**Re: Incorrect Thermal broken Aluminum Joinery: 2 Rapare St. Job No.27363 - JSR Construction.**

From: Harry Lo <harrykhlo@gmail.com>
Sent: Tuesday, 20 December 2022 7:33 PM
To: Ricky Wong <jsrconstruction.nz@gmail.com>
Cc: Matt McLelland <matt.mcllland@hagley.co.nz>
Subject: Re: Incorrect Thermal broken Aluminum Joinery: 2 Rapare St. Job No.27363 - JSR Construction.

Photo 1: Path of thermal conduction at the joint of window transom and sliding-door fixed interlocker and the same photo without marking is given side by side for easy reference

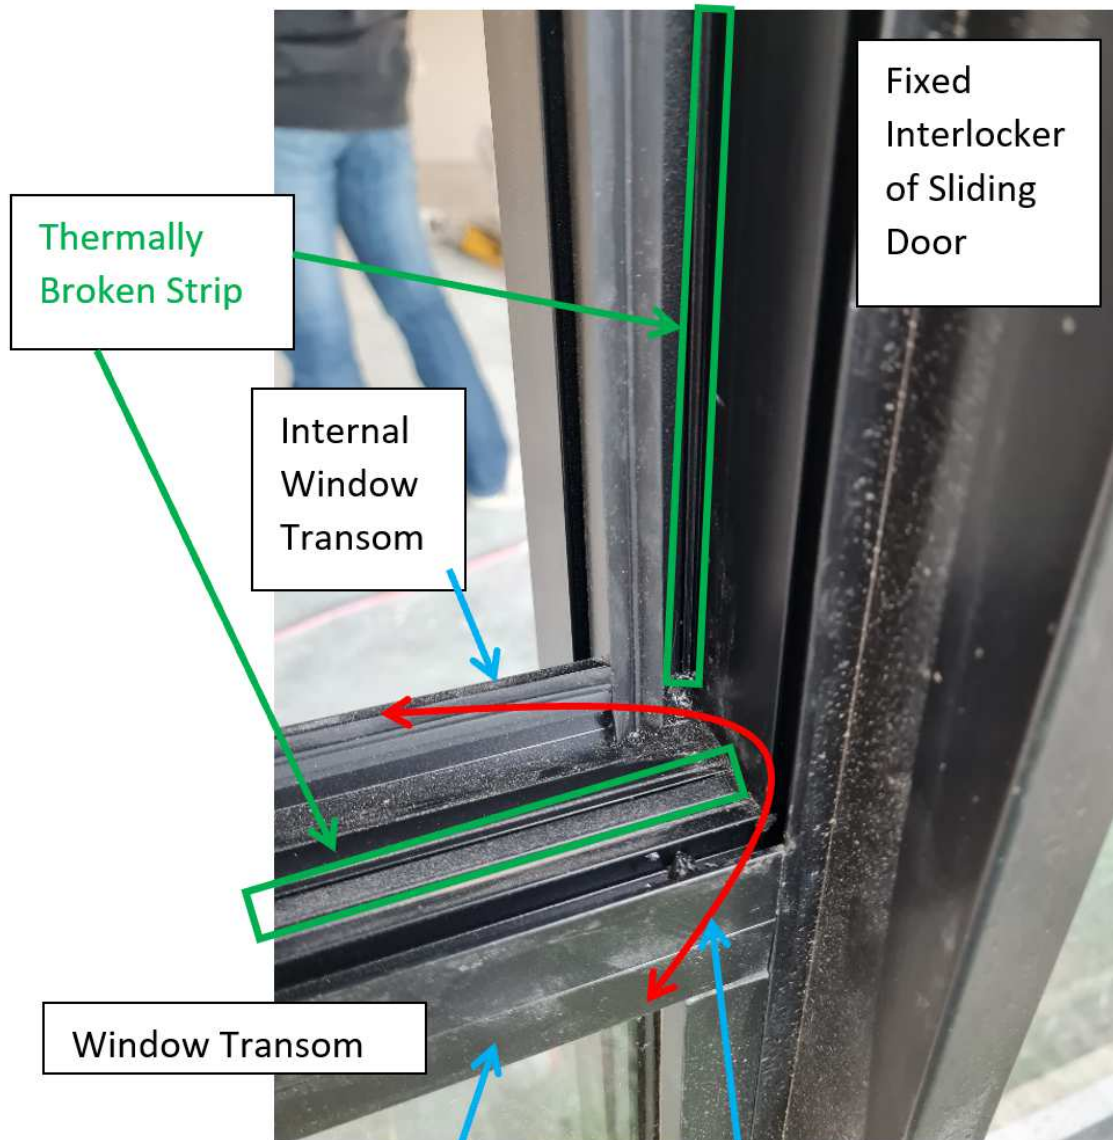
1. You shall replace all non-thermally broken components of the sliding doors and windows which including but not limited to the stiles and fixed interlocker. There is a path of thermal conduction where it is not thermally broken at the joint of the window transom and sliding-door fixed interlocker as indicated by the red line on the marked photo as shown on Photo 1 below. The same photo without marking is given side by side for easy reference. You are required to change the fixed interlocker to have the proper thermally broken strip align with the strip on the window transom. I also took a thermal image (see Photo 2) with the sunshine reaching half the height of the sliding door. It showed that the non-thermally broken components (the joint in between the interlocker and the window transom, and the stiles) creating a thermal conduction between the internal and external parts of the thermally-broken members (e.g. bottom of the sliding door frames and the window transom).

Path of thermal conduction (red
line) between internal and
external parts of the window

I can also confirm that the fixed interlocker has already been supplied as a thermally broken extrusion so this will not be changing, there is no other extrusion or alternative here that could be put in its place and APL have only the one thermally broken fixed interlocker which I can confidently say has been installed as you have pointed out in your photo.

This extrusion has been supplied and installed in line with the APL manufacturing pack provided to us which Hagley and all of APLs other manufacturers follow.

Figure 1 - Photo location plan

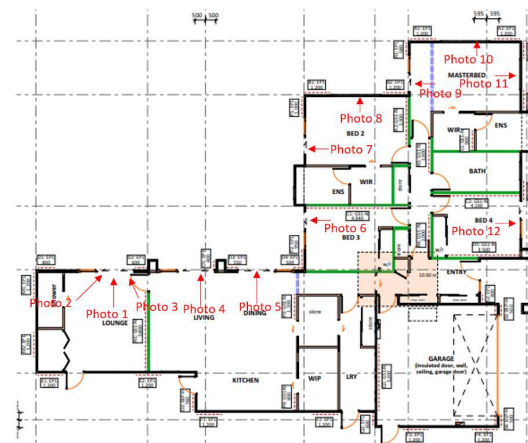
- 1) The parts of the windows and doors frames do not have the thermally broken strip. These windows and doors make up 59% of the area of all the aluminium joinery products. The total area of these problematic aluminium joinery is 28.8 m sq. The total area of all aluminium joinery products is 48.6 m sq. These problematic products are shown in the following photos (note that the photos and the location plan are given at the end of this email):

- 2) The frames of the windows that we are not sure if they are thermally broken or not since the depths of those window frames seems to be smaller than others 32% of the thermally broken joinery by comparing the distances between the frames and the internal and external walls. The total area of these uncertain aluminium joinery is 4.2 m sq. (8.7 % of the total area). These products are shown in the following photos:
